EDGERTON PLANNING COMMISSION AGENDA
REGULAR SESSION
Edgerton City Hall
December 9, 2014
7:00 PM

To: Edgerton Planning Commission
Fr: Kenneth A. Cook, Community Development Director
Re: Application FS-11-06-2014 for the Final Site Plan for Logistics Park Kansas City Southeast, Lot 2 (Inland Port XII)

Final Site Plans Logistics Park Kansas City – Southeast, First Plat, Lot 2 (Inland Port XII)

3 NORTH ELEVATION

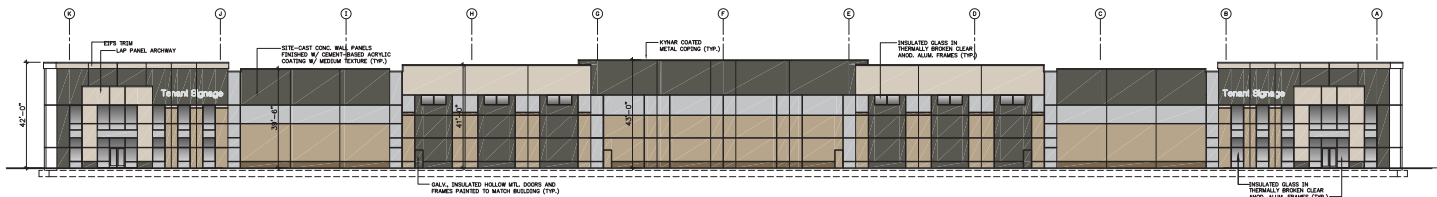
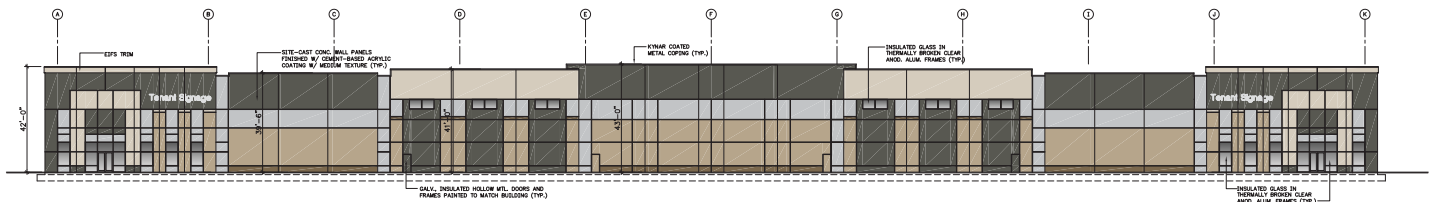
The proposed elevations appear to be consistent with buildings approved and constructed in earlier LPKC phases. The north and west sides of the building face public rights-of-way. The north and south elevations use vertical and horizontal articulation, windows, and color blocking to effectively break up building massing. The west and east façades again use vertical articulation, color blocking, and windows effectively, though the great lengths on these sides provide more opportunities for varying techniques than are taken advantage of in the design. Final Site Plan complies.

4. Façade Guidelines
 - a. Horizontal Articulation. Walls facing a public right-of-way or a residentially zoned property shall not extend for a distance greater than four (4) times the wall's height without having an off-set of ten percent (10%) of the wall's height (maximum of five (5) feet); the new plane shall extend for a distance equal to a minimum of twenty percent (20%) of the maximum length of the first plane. The City may allow exceptions to this requirement upon review and approval of a typical façade elevation. *Walls not facing a public right-of-way or a residentially zoned property and walls with loading dock doors are exempt from the horizontal articulation requirement. The middle of the north wall measures approximately 265*

LANDSCAPE PLAN

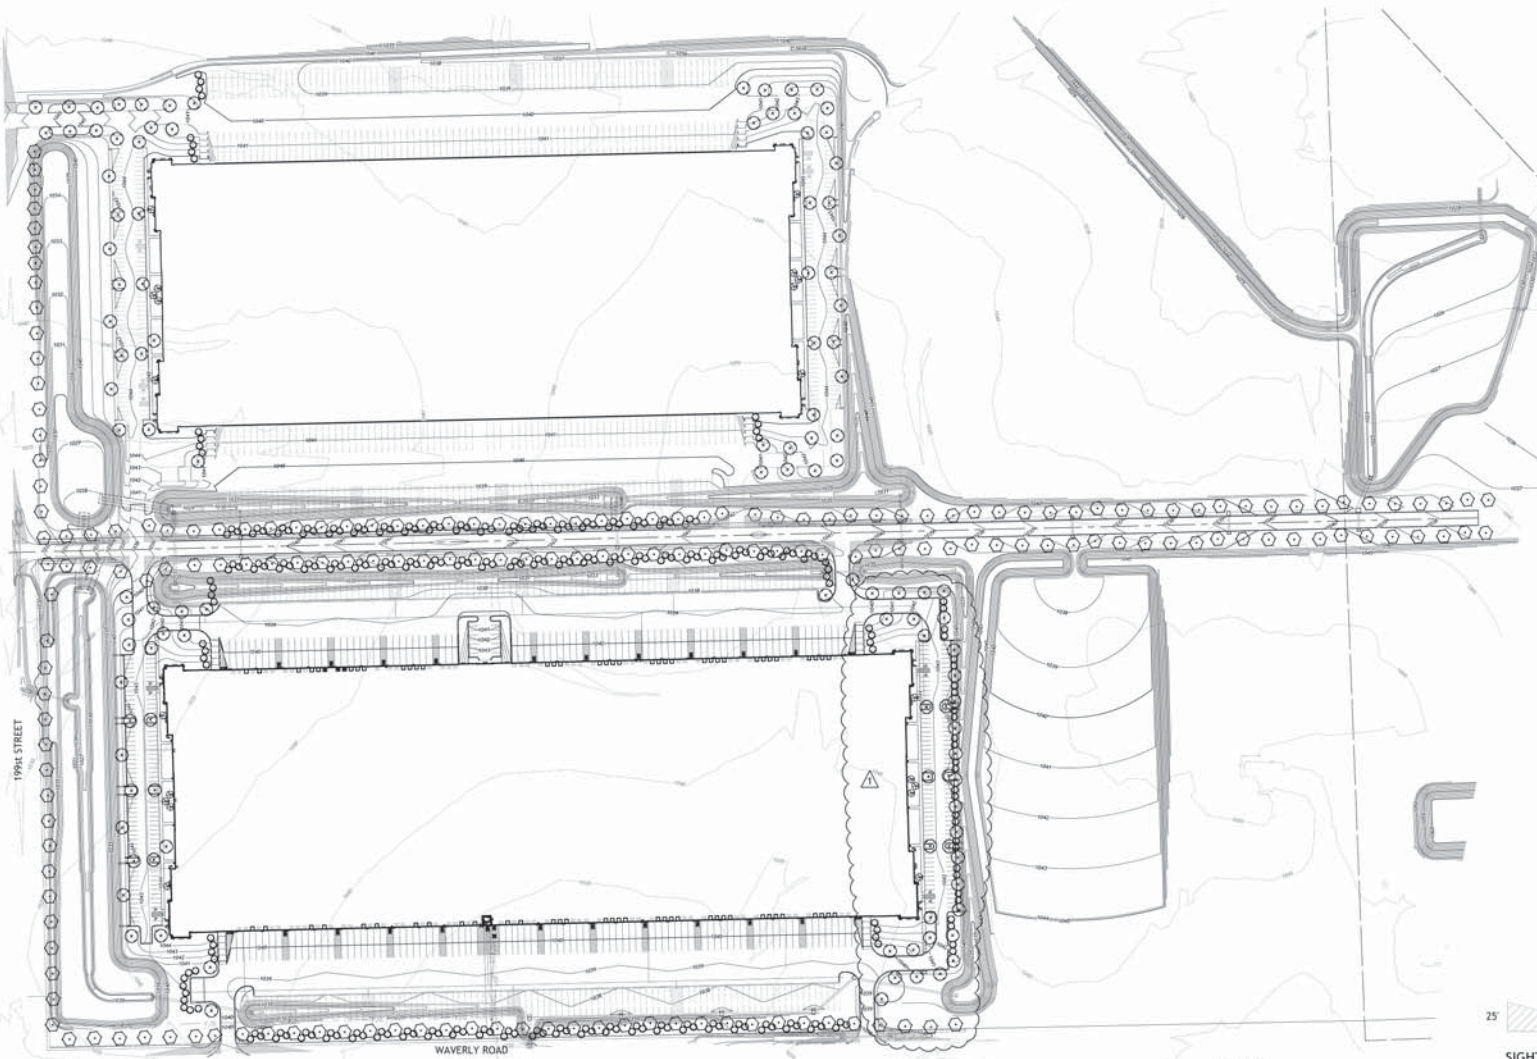
- *Trash containers and screening have not been shown.*
 - *The Landscape Plan incorrectly labels the road to the North of the site as 199th Street on the drawing and in the right of way buffer table. This road is 191st Street.*

- *The road to the west of the site should also be named Montrose Street.*
 - b) A table entitled "Planting Schedule" which lists the common name, size and condition of all planting materials, together with a timetable for planting. *No timeline for planting is included. This table should also be updated to include the quantities for only those materials which are located in this site.*

- ***ROW buffers are required along 191st Street and Montrose Street. These buffers require 1 tree per 50 LF of ROW within a 10 foot buffer width. The ROW buffer shown along Montrose Street has been upgraded to provide additional screening. The screening proposed should be varied more, clusters of trees are "encouraged to create a more natural appearing environment" (Section 5.2.O.4) and the use of berms or other elements can also assist in making a design less monotonous.***

- ***Perimeter Landscape Buffer: Type 1 buffer is required on the south and east property lines to the front face of the building. The type 1 buffer requires a 5' buffer width and trees at 50' spacing (all within the 5' buffer) and hedge/shrub at 48" spacing (with 25% within the 5' buffer). Evergreen trees (Keteleeri Juniper) shall be a minimum 12' height. Deciduous trees shall be a minimum 2.5" caliper. Hedge/shrub shall be a minimum 24" high. Current plans do not include the required hedge/shrub plantings along the Northeast and Southwest portion of the site. Staff also suggests that additional screening be provided along the east property line to provide screening of the loading docks from the ROW and residential properties on the North side of 191st Street.***

5. Dumpster screening: *Trash enclosures or screening are not shown. Plans shall be updated to satisfy the dumpster screening requirements in Article 5.2 K 8. **Provide dumpster screening.***

- b. Construction plans for future public infrastructure be submitted and approved by the City. Any necessary permits obtained.
 - c. Resubmittal of revised landscaping plans including screening for adjacent public roads and trash enclosures. All landscaping shall be maintained in good condition and plants shall be replaced when dead.
